08-08 PENN STATION - SPRINGFIELD, OH

Project Issue Information

Fuse1Tbd03fa608458470a82a756
28a7781dd7.jpeg

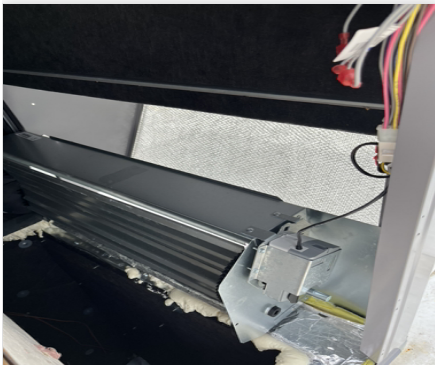
Issue Name : Outside air dampers

Description : On both units the outside air dampers are wide open or are missing a piece. Also unsure how the damper is controlled if everything is correctly installed.

- **08/09/2022** **National TAB - Joe Hertenstein**
 - TO BE ABLE TO BALANCE TOTAL AIRFLOW, & TRY TO SET OUTSIDE AIR, TEMPORARILY CLOSE OFF WITH CARDBOARD & TAPE & DOCUMENT. CONTACT GC/MC TO GET PERMANENT SOLUITION.
